Refining TDECQ (continued)

Piers Dawe

Mellanox

Not all maximum-TDECQ signals are equal

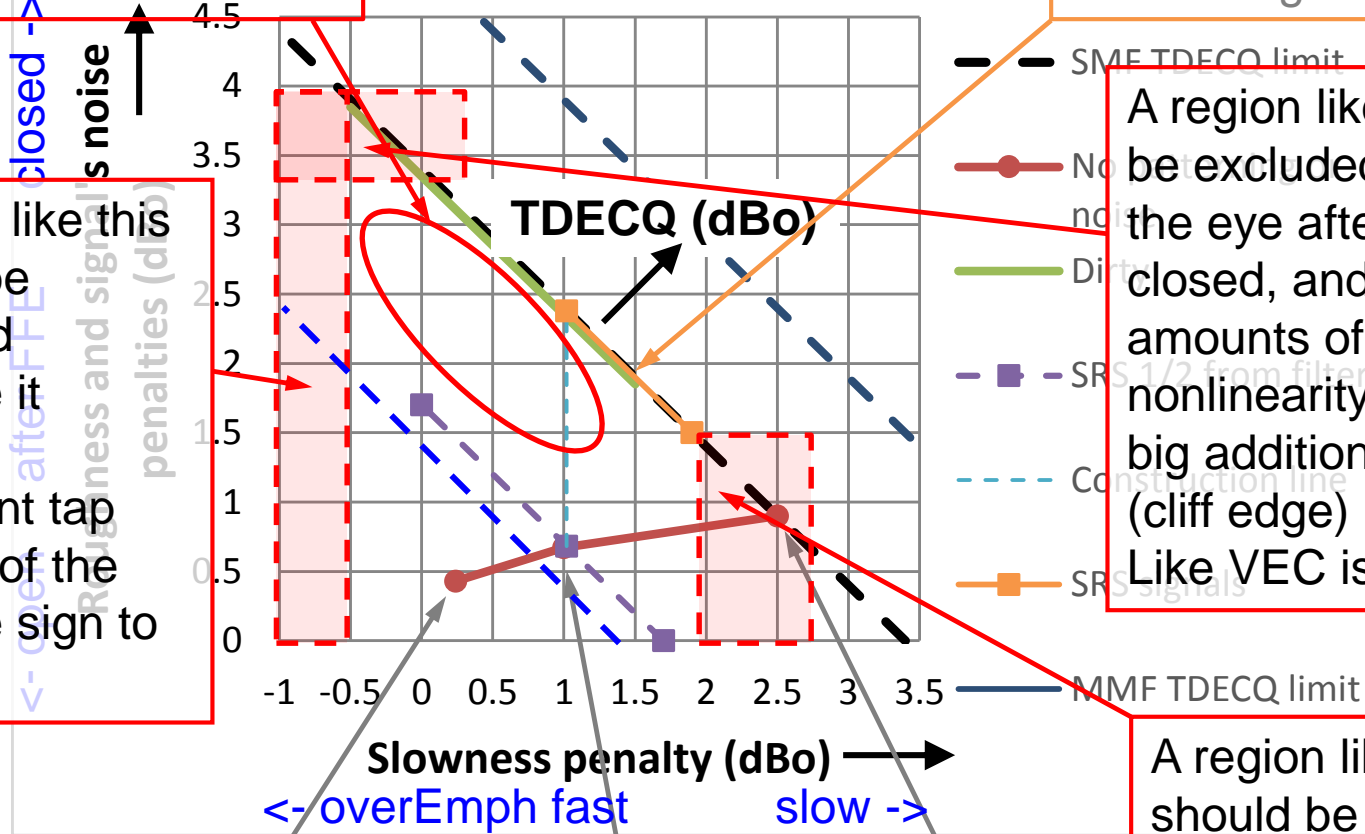
A region like this should be excluded because it requires significant tap weights of the opposite sign to normal

A region like this should be excluded because the eye after FFE is very closed, and small amounts of e.g. nonlinearity would cause big additional penalties (cliff edge) Like VEC issue in C2M

A region like this should be excluded because it requires strong tap weights not useful in practice, and is not screened for in SRS

"Exclusion" could be by giving signals in the red boxes worse TDECQ scores, or by "hard" pass-fail rules

Same transmitter in 25G PAM2 mode, 19.34 GHz BT4

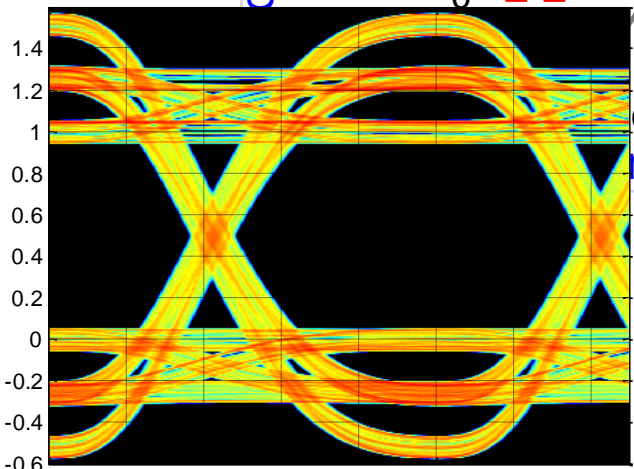
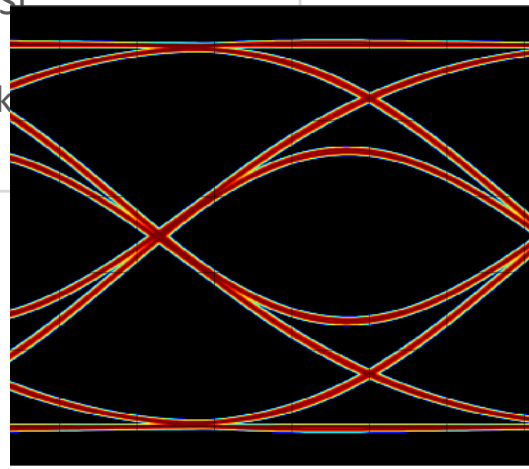
The signal on the left is bad because nothing can be done to improve it – neither sensitivity nor EQ. Worse is allowed by the draft
